Memorandum

Subject: **Peer Review of Updated Traffic Study for the Proposed Terraces of Lafayette Project**

Figure 3. Bicycle Conflict Zones

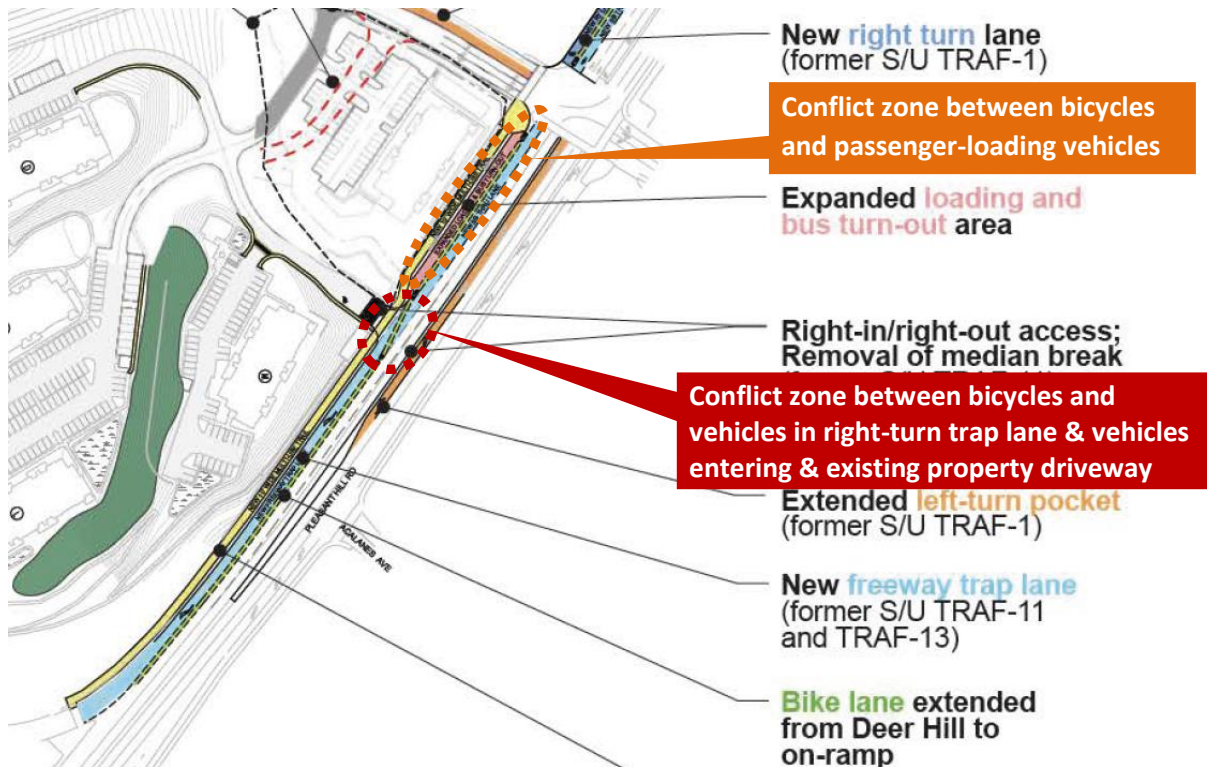
The proposed bicycle lane between Deer Hill Road and SR 24 on-ramp would be located between the right-turn trap lane and through lanes, as illustrated in **Figure 3**. This will create two major neighboring conflict zones for bicycles, as listed below.

- Conflict zone between bicycles and passenger-loading vehicles, as illustrated in the area circled in orange.
- Conflict zone between bicycles and vehicles in the right-turn trap lane where bicycles need to cross the trap lane, and between bicycles and vehicles entering & existing the property driveway, as illustrated in the area circled in red.

The updated traffic study did not address these significant conflicts in the neighboring conflict zones between bicycles and vehicles.

Figure 4. Very High Fire Hazard Severity Zones, City of Lafayette¹

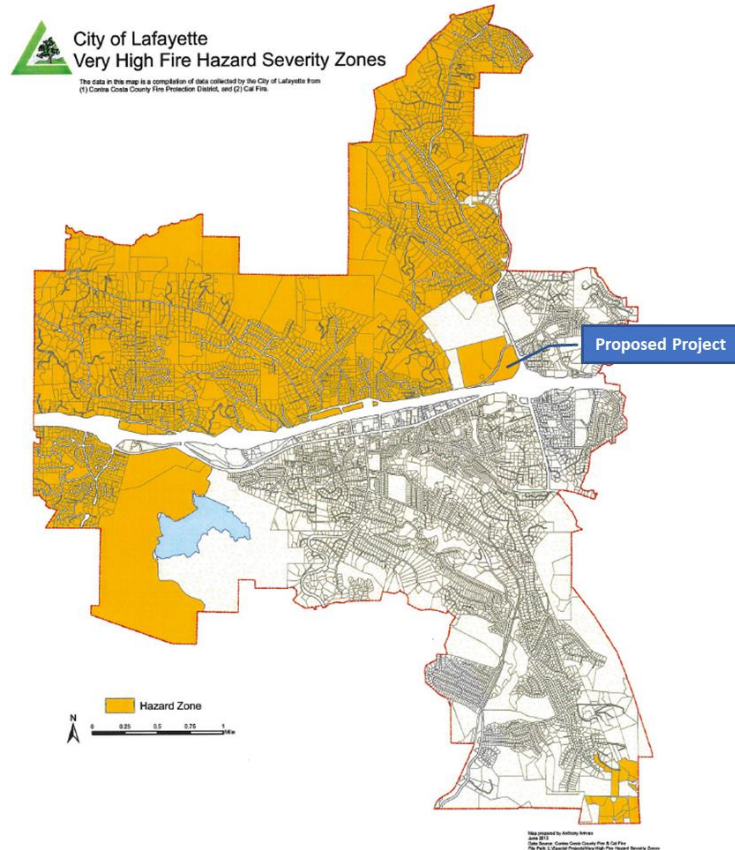
It is worth noting that the proposed project is located in the Very High Fire Hazard Severity Zones (VHFHSZ) according to the City Ordinance No. 620 (**Figure 4**). Given the facts that: 1) semi-rural/urban interface wildfires have become a new reality; 2) all three fire stations within the study area use Pleasant Hill Road, and 3) all three fire stations fail to meet the target response time of five minutes, the extra delay on Pleasant Hill Road caused by the proposed project would worsen emergency response time as well as resident evacuation.

In addition, PG&E’s power shut-offs, as a proactive measure to help avoid wildfires, have been affecting the study area and surrounding areas. As a consequence, affected signalized intersections become all-way-stop-controlled intersections due to traffic signal blackout (which would also affect any proposed EVP system also). It is recommended that the study should include an analysis to quantify the traffic impact of the proposed project under such conditions.

In addition, an evacuation plan for the residents in the area should be considered and how the proposed project would impact evacuation routes and emergency vehicles access if the proposed 315 units are being evacuated at the same time.
